South Texas Project Electric Generating Station P.O. Box 289 Wadsworth, Texas 77483

December 09, 2009  
NOC-AE-09002491  
File No.: G25  
10CFR50.55a

South Texas Project  
Unit 2  
Docket No. STN 50-499  
Amended Request for Relief from ASME Boiler and Pressure Vessel Code  
Section XI Requirements for the Essential Cooling Water System  
(Relief Request RR-ENG-2-52) (TAC ME0899)

**RELIEF REQUEST RR-ENG-2-52:  
RESPONSE TO REQUEST FOR ADDITIONAL INFORMATION**

Figure 1

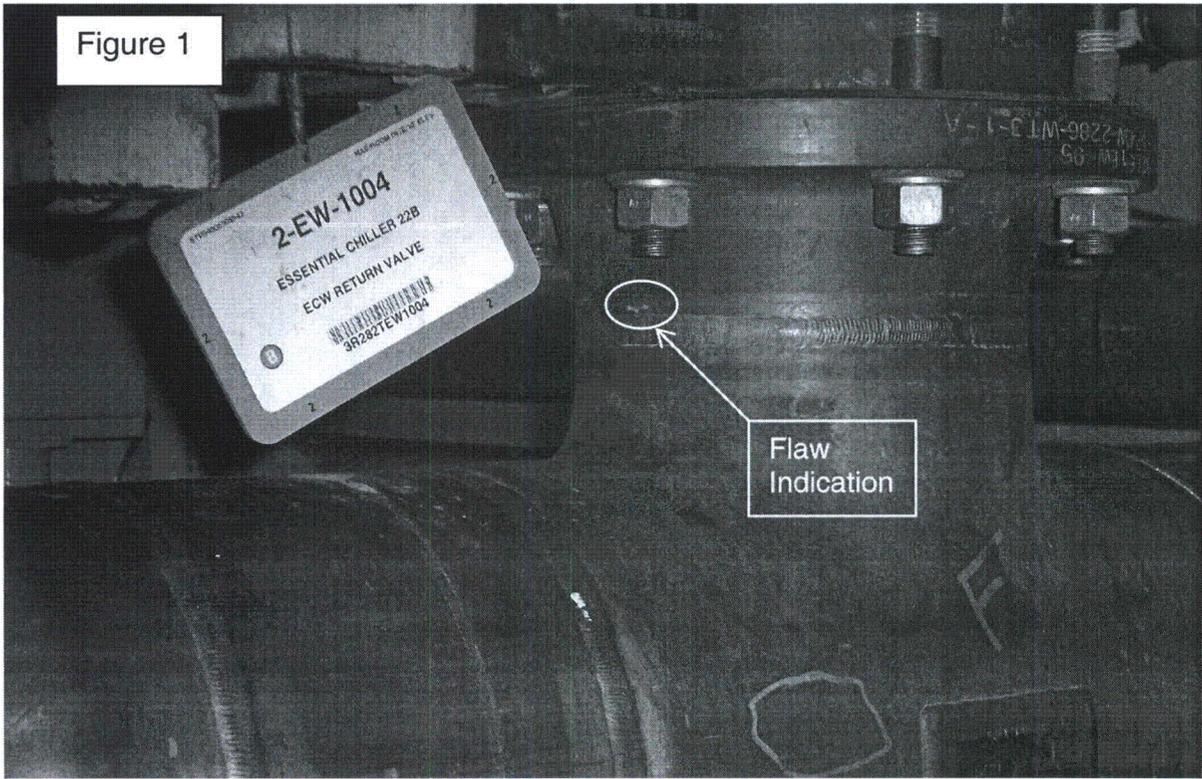
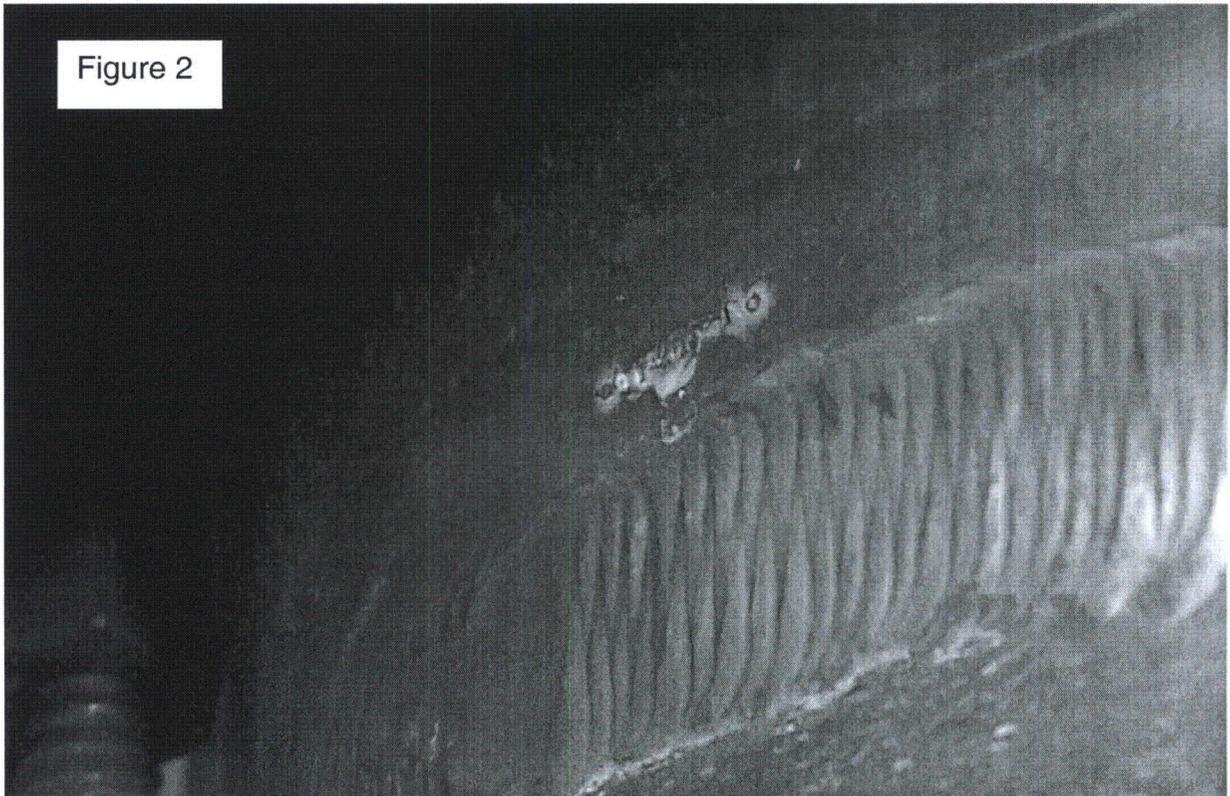
- 2(d) Discuss whether the flaw is in the circumferential or axial direction.

The circumferential orientation of the flaw can be seen in Figures 1 and 2. The circumferential orientation is also stated in paragraph 1(d) of the original submittal.
